Technical Service Bulletin

SUBJECT: TSB-19-54-007 No: **UPDATED FCM/LDW/AHB-ECU SENSOR** March 2019 DATE: **CALIBRATION PROCEDURE** MODEL: 2017 Outlander - SERVICE MANUAL REVISION **CIRCULATE TO:** [] GENERAL MANAGER [X] PARTS MANAGER [X] TECHNICIAN [X] SERVICE ADVISOR [X] SERVICE MANAGER [X] WARRANTY PROCESSOR [] SALES MANAGER

This TSB updates the Chassis Electrical section of the affected Service Manual, to update the FCM/LDW/AHB-ECU sensor calibration procedure.

ACG01776AB

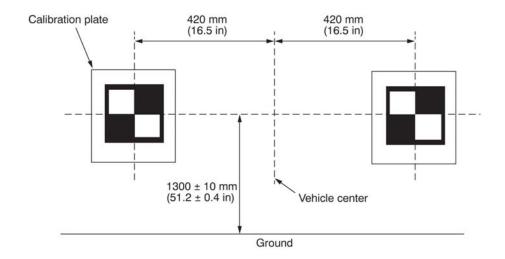
(3) Place the calibration plate and the vehicle as shown.

Calibration plate position

<Old>

Distance between the sensor on the FCM/LDW/AHB-ECU and the calibration plate 2500 \pm 10 mm (98.4 \pm 0.4 in)

[Distance between the center of the front axle and the calibration plate: 1737 mm (68.4 in)]

• Dimension (height) between the floor and the center of the calibration plate: 1300 \pm 10 mm (51.2 \pm 0.4 in)

<New>

Distance from the edge of the FCM/LDW/AHB-ECU sensor to the calibration plate
